MEMORANDUM

Re: Geohydrologic Review

GZA GeoEnvironmental, Inc. (GZA) has completed a geohydrologic review at the 6 Manitou Court, Westport, Connecticut (Site). This memorandum was prepared to address one of the Connecticut Department of Energy and Environmental Protection (CTDEEP) comments in their May 29, 2020 letter (comment 2G). Specifically, we evaluated whether the upland groundwater seeps have the potential to cause slope failure that would impact the nearby seawall, and other proposed structures. Our services were conducted in accordance with our proposal dated June 18, 2020. This memorandum is subject to the Limitations provided in Appendix A.

**6 MANITOU COURT
WESTPORT, CONNECTICUT**

Figure 1- Test Pit Location Plan

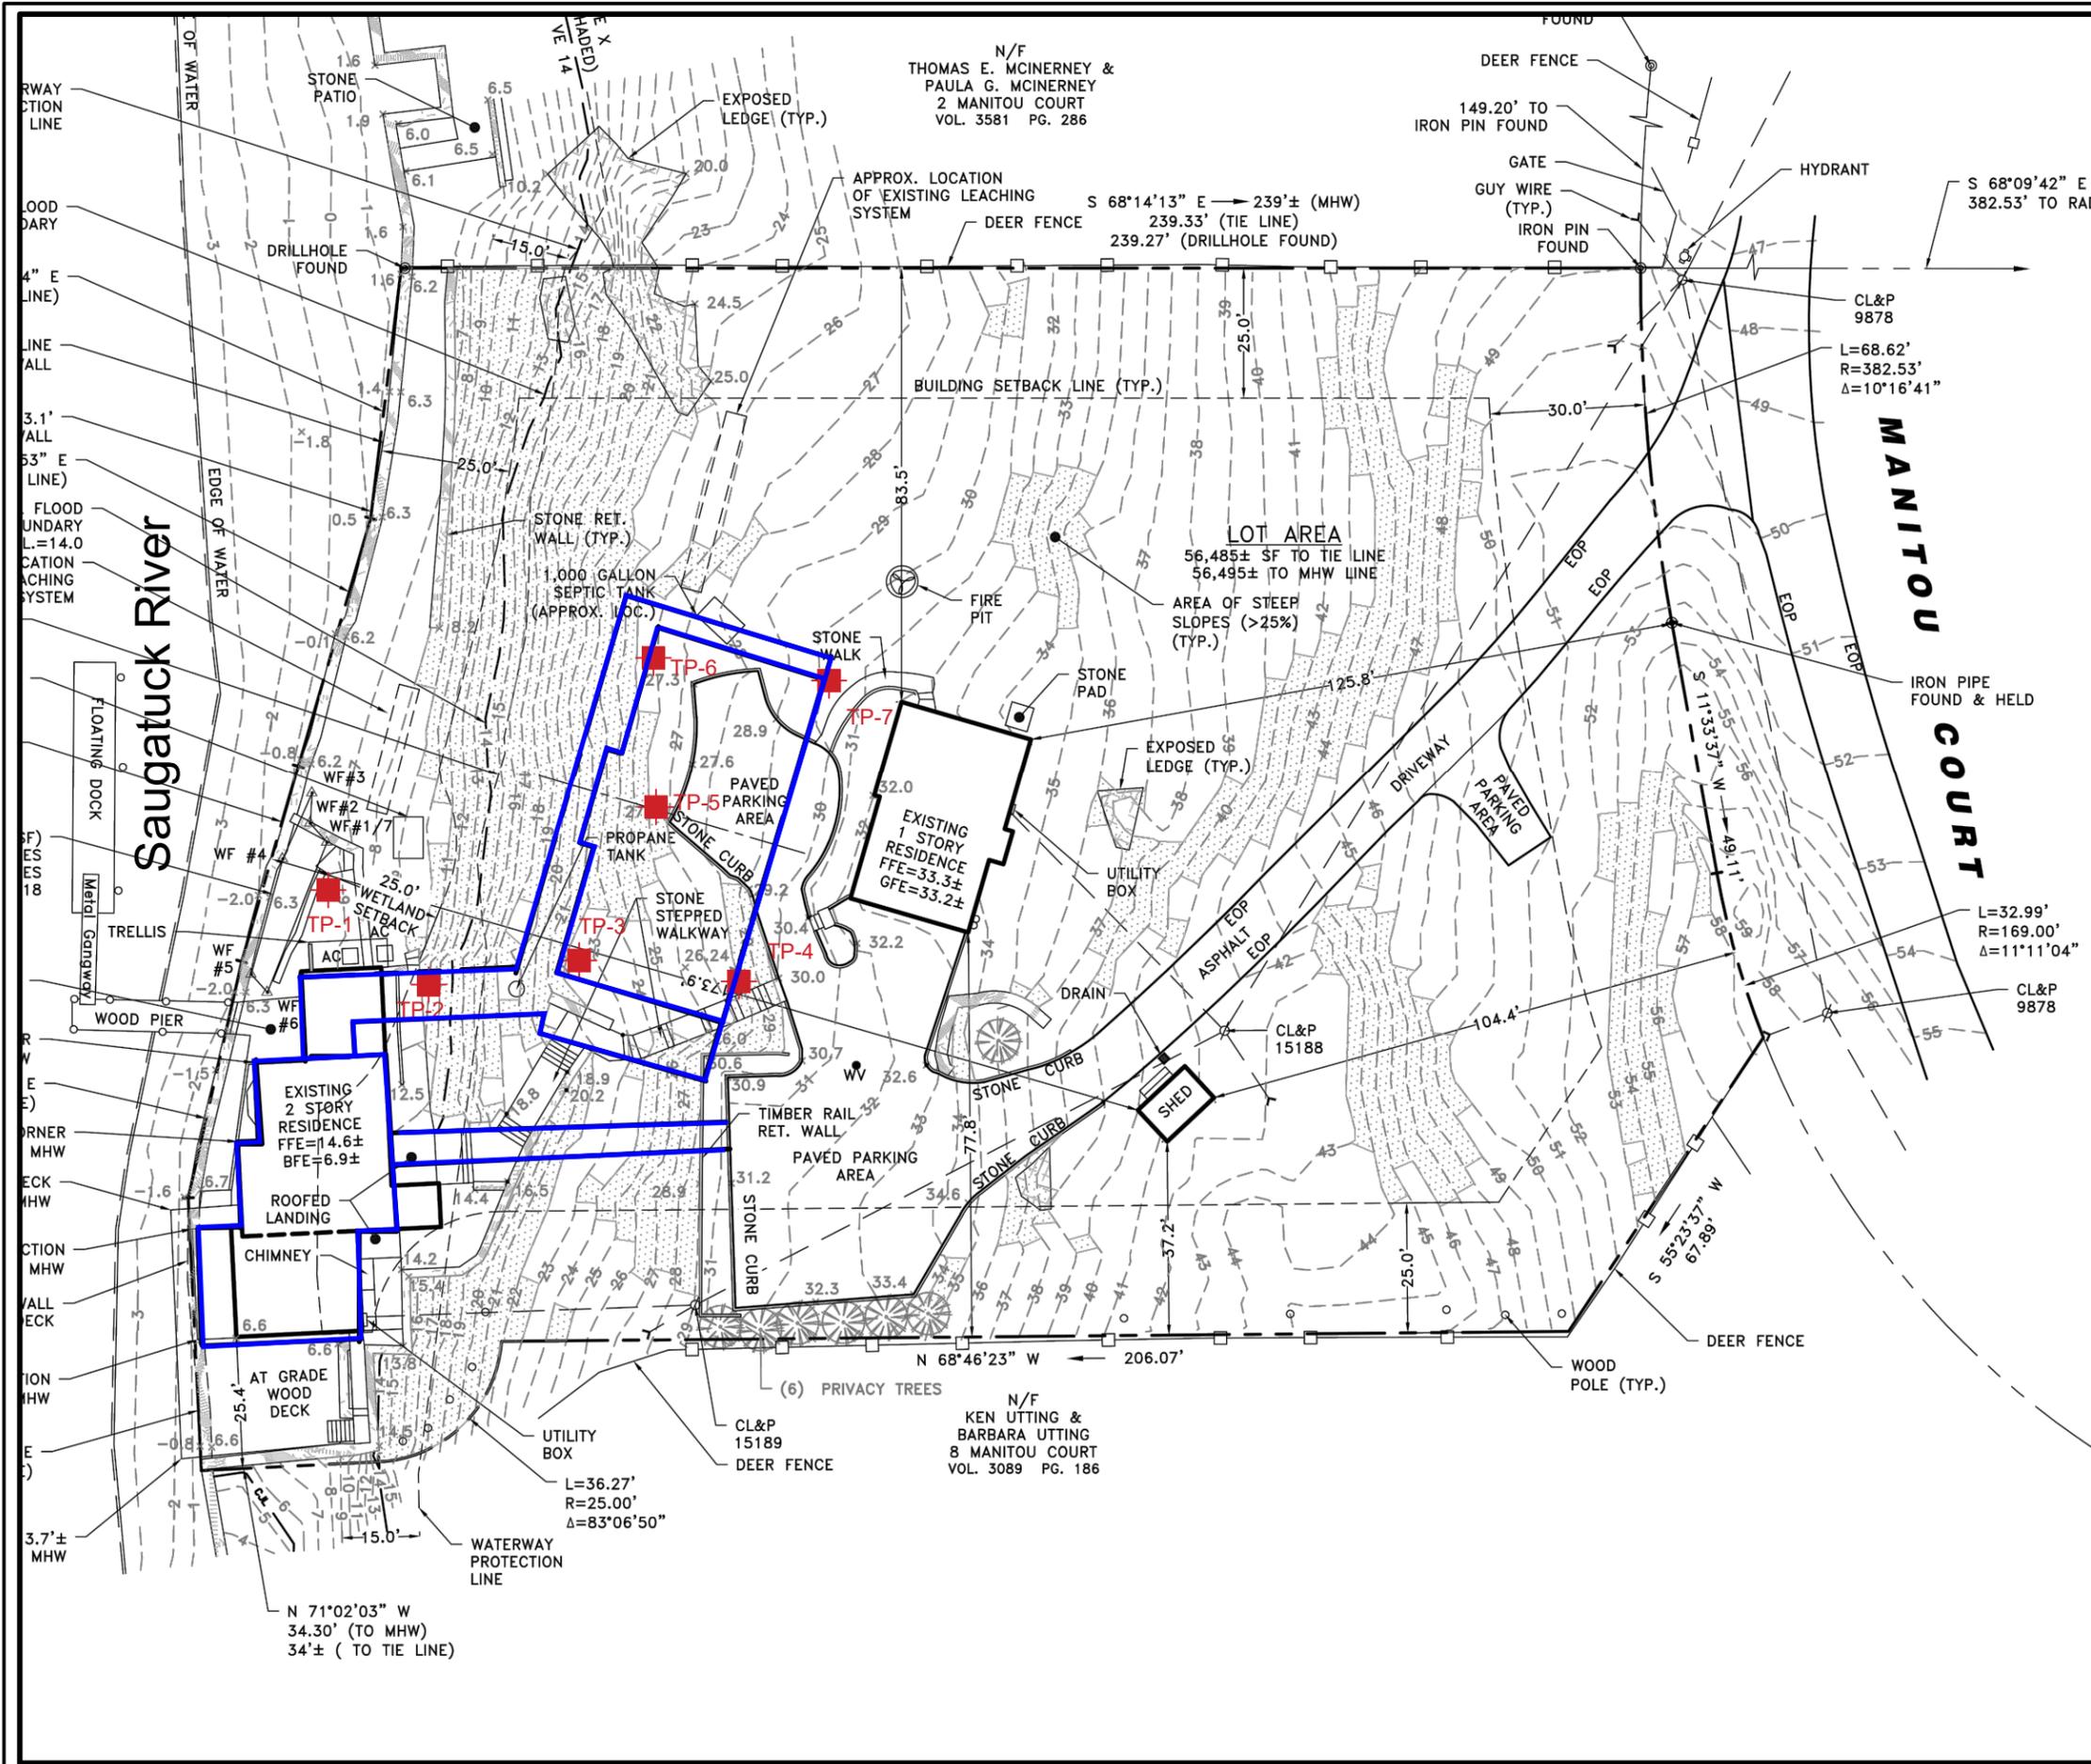
GZA observed seven test pit explorations performed at the Site on April 10, 2020 (see Figure 1 for test pit locations). The subsurface conditions encountered at TP-1 (near the sea wall) was generally silty sand from 0 to 5.5 feet, organic silt from 5.5 to 6 feet, gravely sand from 6 to 7 feet, and refusal on bedrock at 7 feet. The remaining test pits generally encountered silty, gravely sand with cobbles to the top of the bedrock surface. Bedrock was encountered at depths ranging from 3 to 5 feet below grade in these test pits. Refer to GZA's May 29, 2020 geotechnical report for more details on subsurface conditions.

Groundwater was observed in TP-1 at a depth of 7 feet below existing grade, corresponding to El. 2 feet. Groundwater was not encountered in the remaining test pits. It should be noted that groundwater levels will vary due to tidal influences from the Saugatuck River, seasonal and climatic fluctuations, and changes caused by construction and stabilization time.

A shallow channel of soil erosion was observed going down the slope originating at the edge of the paved parking area (near test pit TP-5). This is a low point of the paved parking area and at the base of a long driveway. It is GZA's opinion that this soil erosion was caused by surficial runoff of the paved surface, and not groundwater seepage. There was no orange staining of the soil in this area.

5. All of the earth retaining walls should include either weep holes spaced 4 feet on center or include drainage at the base of the retaining walls.
6. The downgradient side of the paved surfaces should incorporate a large enough curb to prevent large storm events from overtopping the curbs. In addition, a stone filled groundwater interceptor trench should be located downgradient of the pervious pavement area and should be piped to an area that will not cause surficial erosion or groundwater seeps.
